RECORD DRAWING
BASED ON CONTRACTOR MARKUPS,
NOT FIELD SURVEY.

BW2 JOB NO. 10-1424 AND 11-1471

RECORD DRAWING

WASTEWATER SYSTEM IMPROVEMENTS
WASTEWATER GRAVITY SEWER AND LIFT STATION

WASTEWATER SYSTEM IMPROVEMENTS
WASTEWATER GRAVITY SEWER AND LIFT STATION
LINE "A" - PLAN AND PROFILE
(STA. 56+00 TO STA. 60+53.75)
CITY OF LUCAS

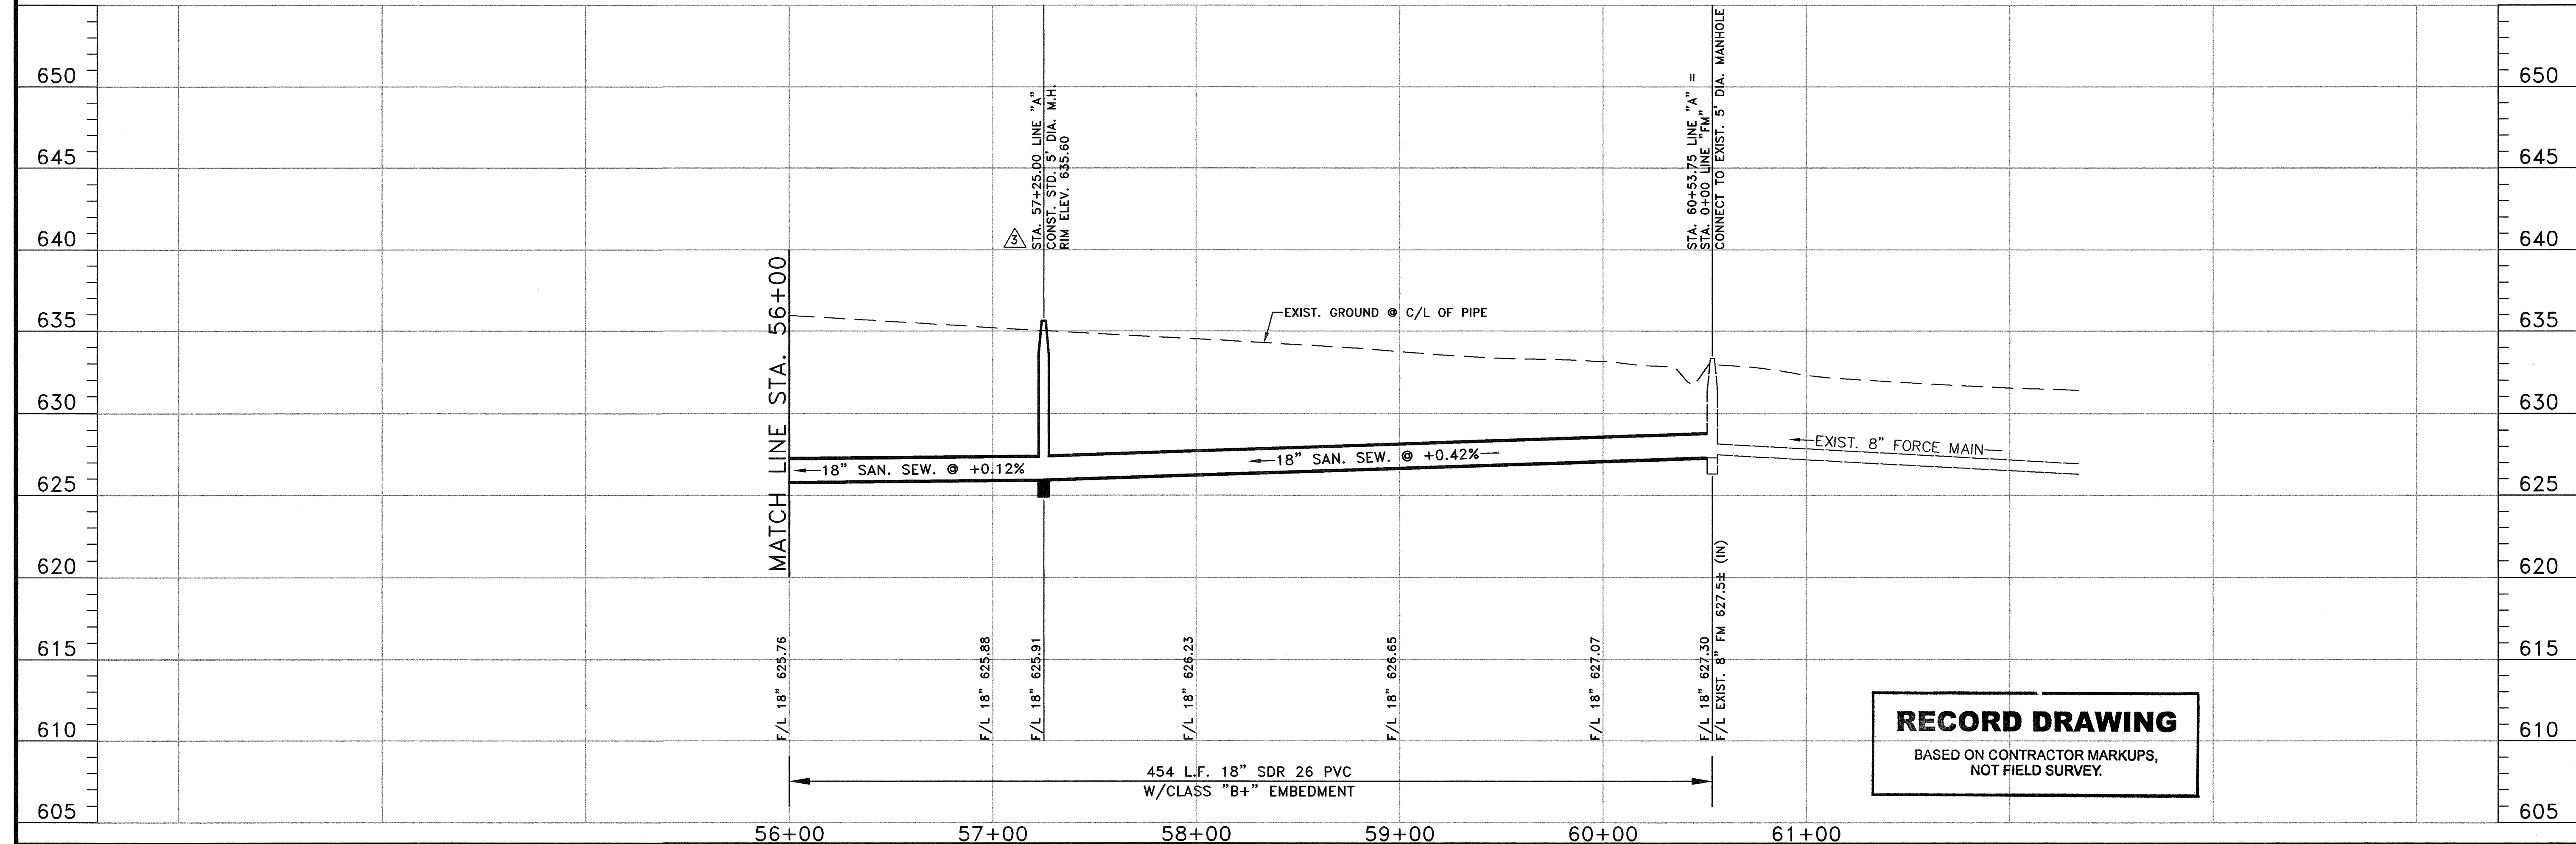
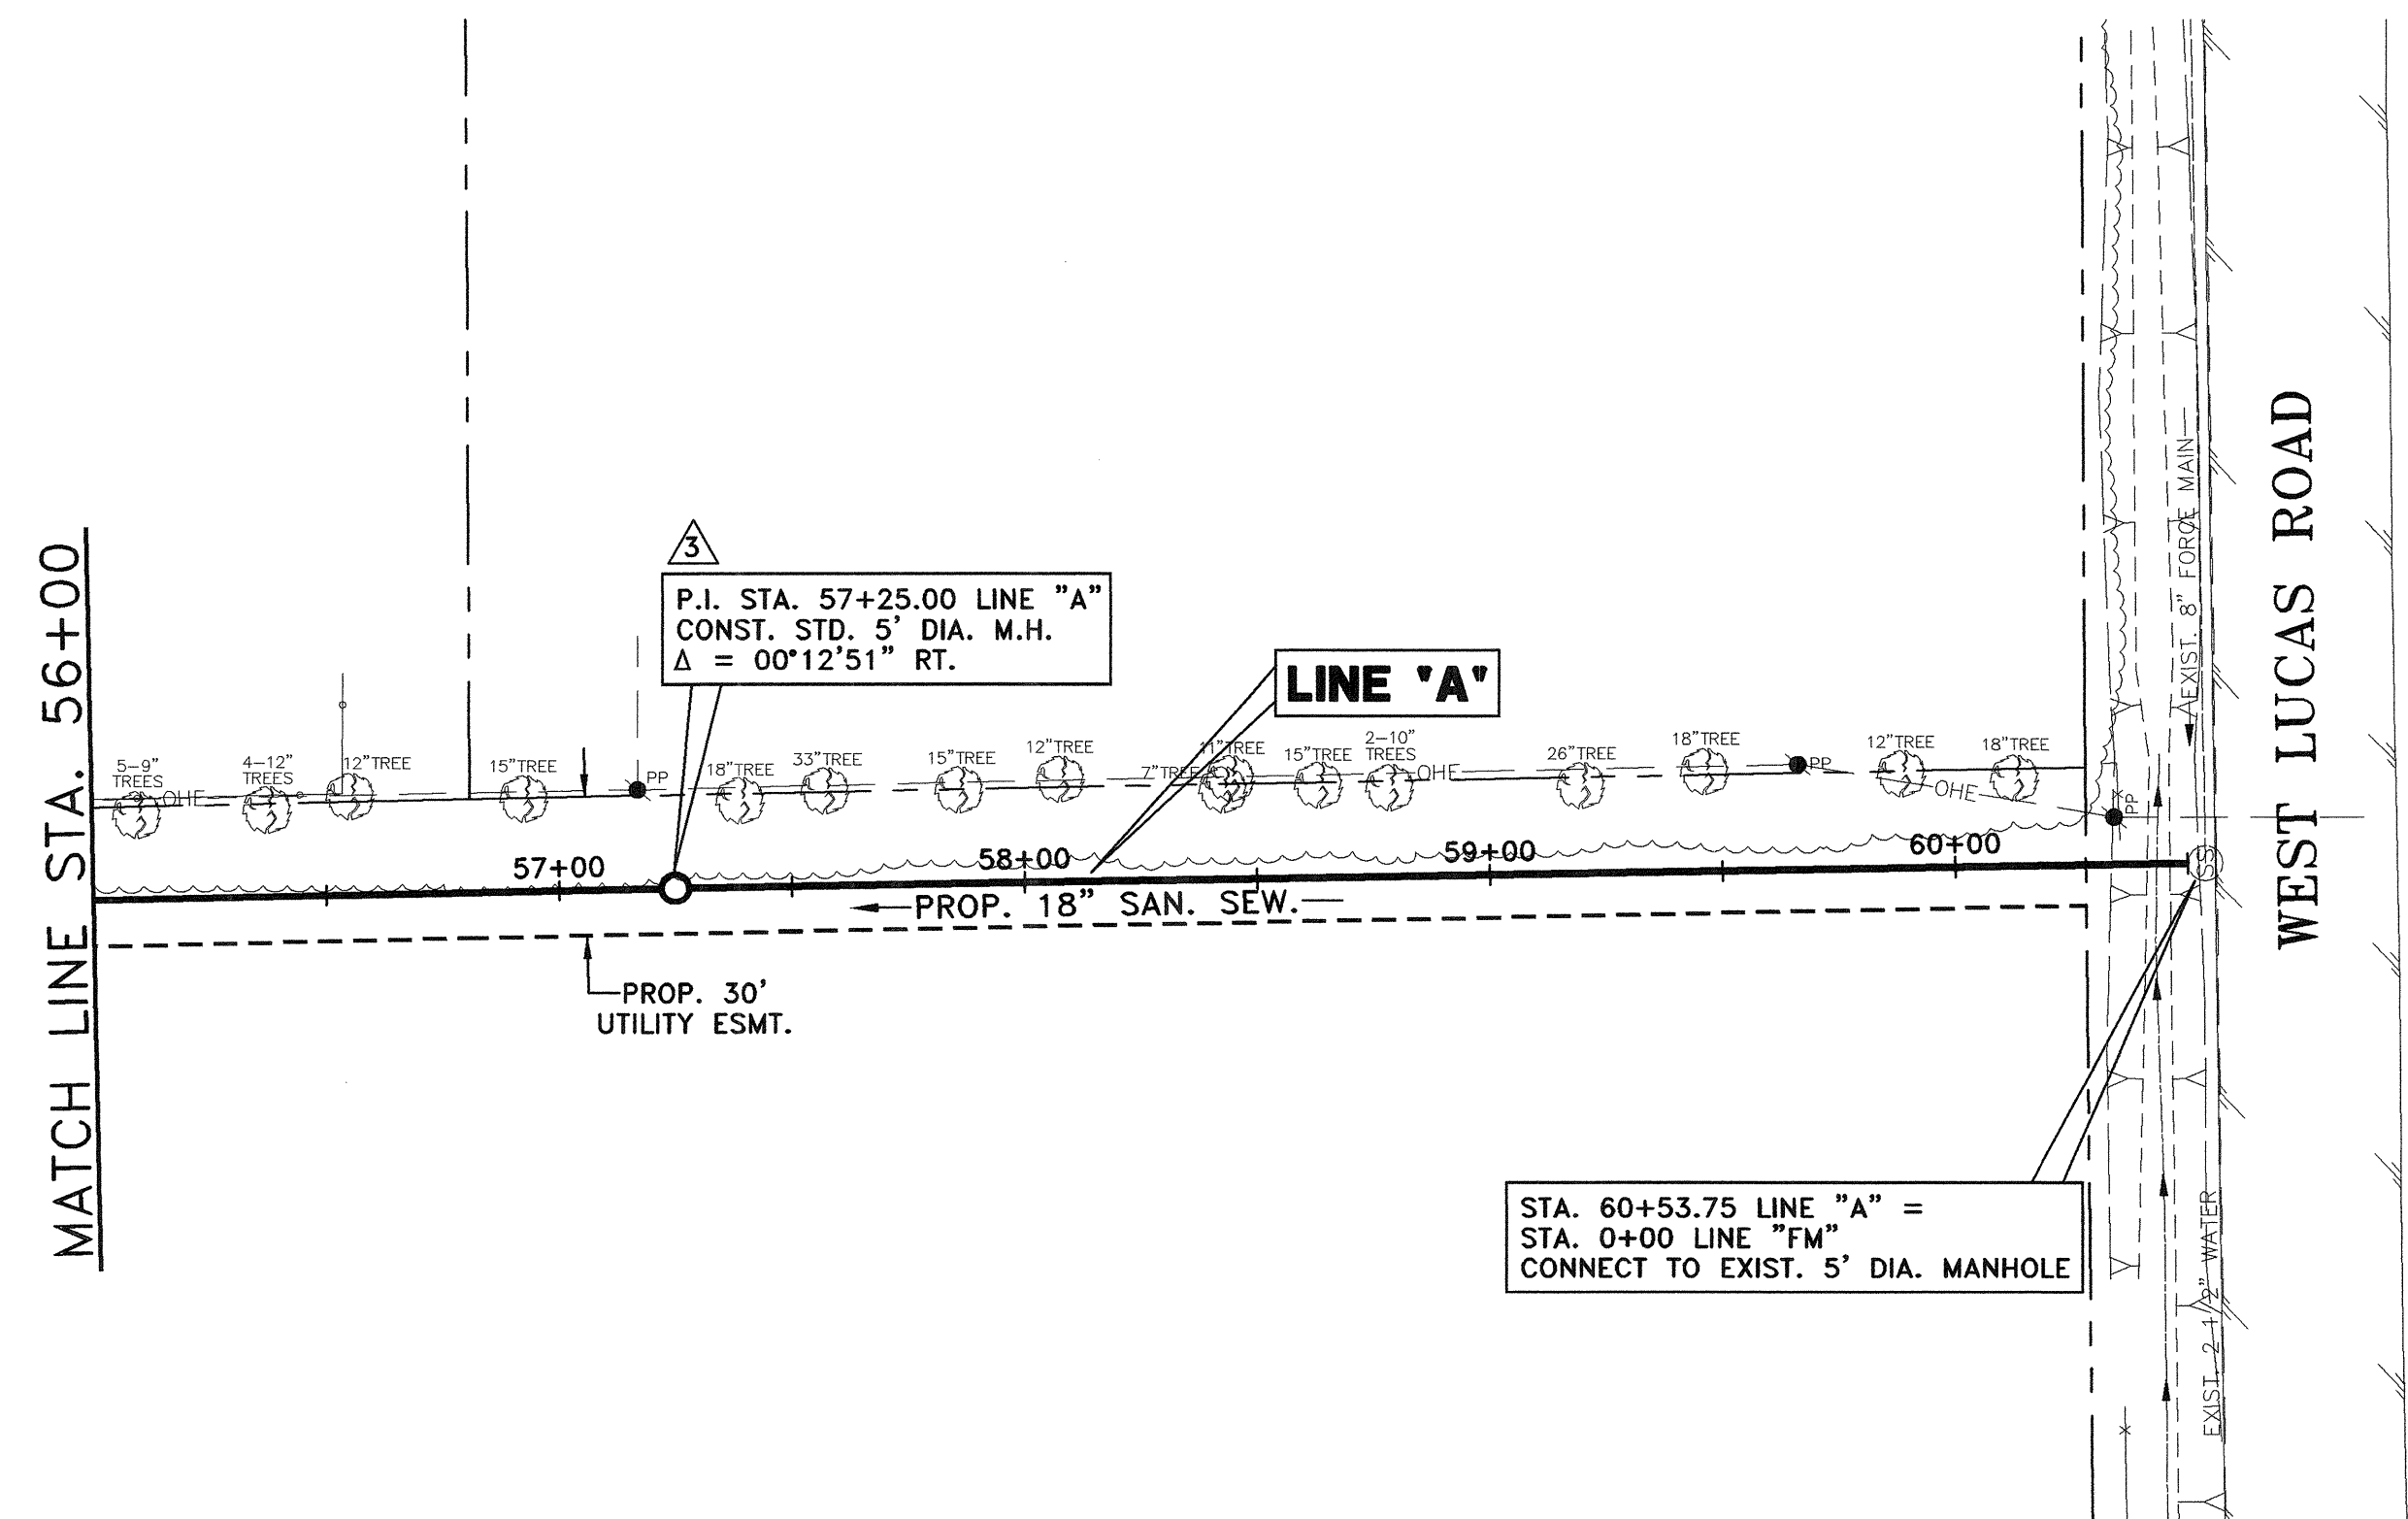
- NOTES:**
1. REVISED THE ELEVATIONS OF THE PROPOSED PIPELINE AND PROPOSED MANHOLES BY LOWERING ALL OF THE ELEVATIONS BY 0.70 FEET.
 2. THE PIPE STIFFNESS FOR ALL THE PIPES SHALL BE A PS OF 115 PSI. WHERE THE COVER OVER THE PROPOSED 18" SANITARY SEWER EXCEEDS 20', CLASS "C" EMBEDMENT (CONCRETE ENCASEMENT) SHALL BE UTILIZED. WHERE THE COVER OVER THE PROPOSED 18" SANITARY SEWER IS 20' OR LESS, CLASS "B+" EMBEDMENT SHALL BE UTILIZED. WHEN THE CONCRETE ENCASEMENT IS BEING PLACED FOR THE CLASS "C" EMBEDMENT, THE CONTRACTOR SHALL PLACE THE CONCRETE ENCASEMENT BY TREMMIE OR SMALL BUCKET; DROPPING CONCRETE ON TOP OF THE PIPE DIRECTLY FROM THE CONCRETE TRUCK CHUTE WILL NOT BE PERMITTED. CONTRACTOR SHALL TAKE ALL MEANS NECESSARY TO MAINTAIN THE CORRECT GRADE ON THE PROPOSED PIPELINE AND TO PREVENT THE PIPE FROM FLOATING WHEN PLACING THE CONCRETE ENCASEMENT. EXCAVATED ROCK FROM THE TRENCH AREA IS NOT A SUITABLE BACKFILL MATERIAL AND SHALL BE HAULED OFF THE CONSTRUCTION SITE AND DISPOSED OF ELSEWHERE. THE COST OF ALL OF THIS WORK SHALL BE INCLUDED IN THE PRICE BID FOR THE ITEMS, AND THERE SHALL BE NO EXTRA PAY FOR ANY OF THIS WORK.

NO.	DATE	REVISION	REVIEWED
6			
5			
4			
Δ	7/31/12	REVISED MANHOLE LOCATIONS PER FIELD CONDITIONS	MRB
Δ	7/13/12	REVISED PER ADDENDUM NO. 5	MRB
Δ	7/13/12	REVISED PER ADDENDUM NO. 2	MRB
